ADDENDUM

“DATASPEED®” PRINTER

RECEIVE-ONLY STATION

CHECKOUT AND TROUBLESHOOTING

Figure 19 - Location of Knockouts on Power Supply Fuses

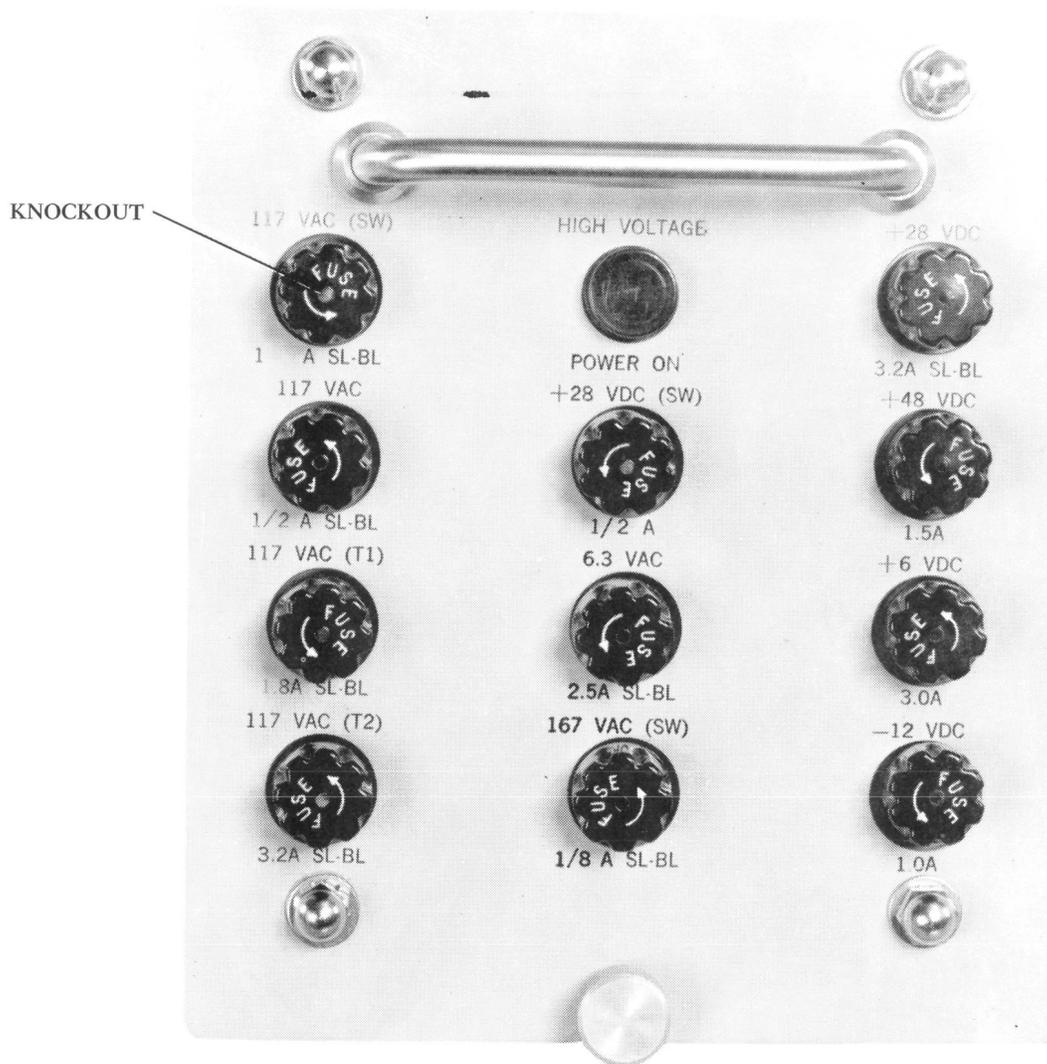
Note: All power supply fuses have plastic knockouts in the center of the cap (Figure 19). A meter can be used to measure voltages at fuses (through knockouts) with respect to frame to determine whether any voltages are missing or too low.
